STAFF REPORT
KETCHUM PLANNING AND ZONING COMMISSION
SPECIAL MEETING OF AUGUST 23rd, 2022

PROJECT:	The Perry Building
FILE NUMBER:	P22-045
APPLICATION:	Pre-Application Design Review
PROPERTY OWNER:	The Perry Building LLC
DEVELOPERS:	Carson Palmer and Broderick Smith
ARCHITECT:	Tiina Ritval, GGLO
LOCATION:	131 W 4th Street and 471 & 431 N 1st Avenue (Ketchum Townsite: Block 56: Lots 2, 3A, and 4A)
ZONING:	Mixed-Use Subdistrict of the Community Core (CC-2)
OVERLAY:	None
REVIEWER:	Abby Rivin, Senior Planner

The Perry Building Pre-Application Design Review

Figure 2: Section A (Project Plans Page 39)

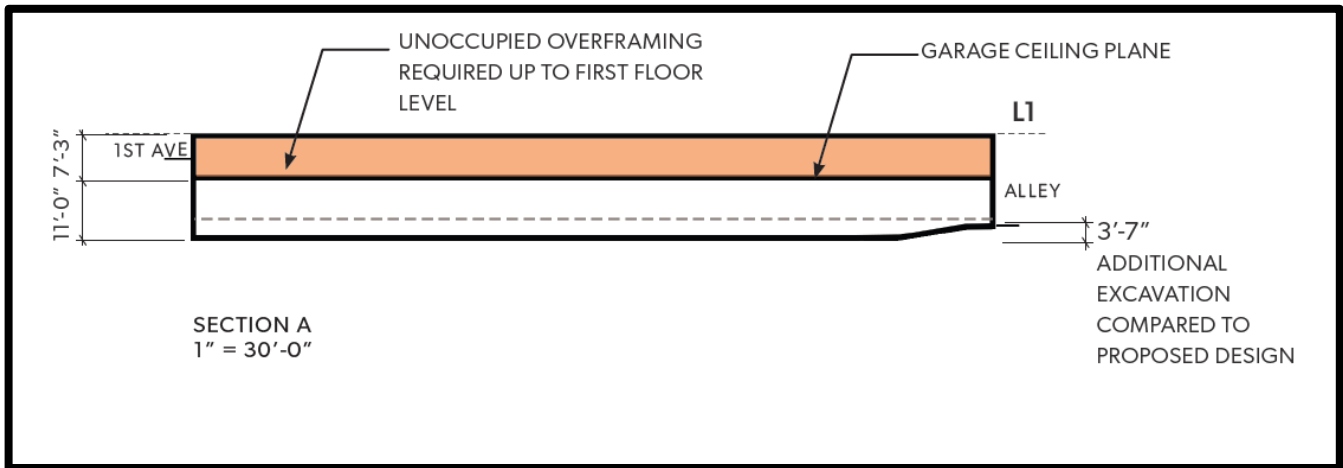
The proposed project includes a variance request to exclude the underground parking garage from the gross floor area calculation. Pursuant to Ketchum Municipal Code §17.08.020, underground parking garages may be excluded from the gross floor area calculation provided that a minimum of 75% of the ceiling surface area of the floor level is not more than 4 feet above the basement invisible plane. The Perry Building parking garage does not meet this required standard to qualify as an underground parking garage. The parking garage falls 8'-10" below grade at the street corner and rises 8'-6" above grade at the northwest corner of the property along the alley. Lowering the proposed parking level further below the basement invisible plane in order to qualify as an underground parking garage would require significant excavation. Additional framing would also be required to raise the main level up to meet the sidewalk grade (See Figure 2). Staff recommends the Commission review the applicant's variance request detailed on pages 38, 39, and 40 of the project plans and provide feedback to the applicant.

Figure 6: Tall Wall (Project Plans Page 30)

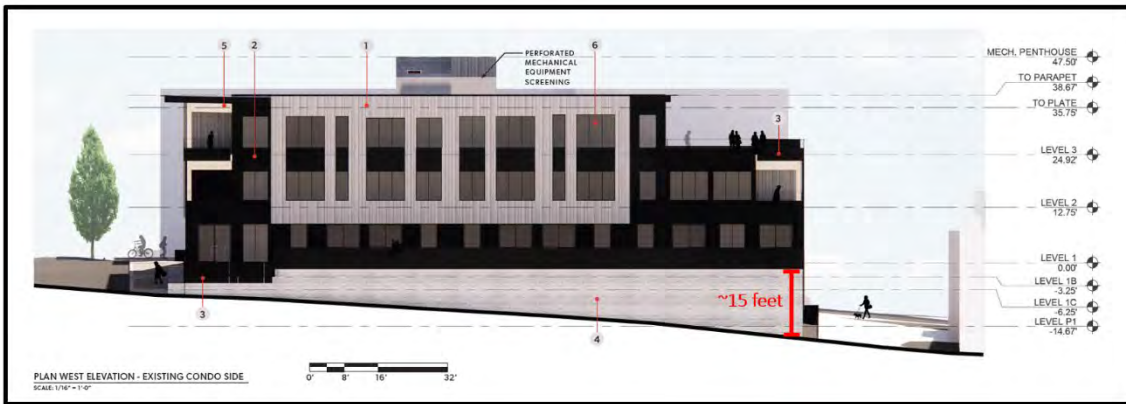
The west elevation on page 30 of the project plans shows a board-formed concrete wall that borders the interior side property line. This 15-foot-tall-wall appears flat and monolithic (See Figure 6). Staff recommends that the applicant modify the design of this wall to soften its appearance and add visual interest.
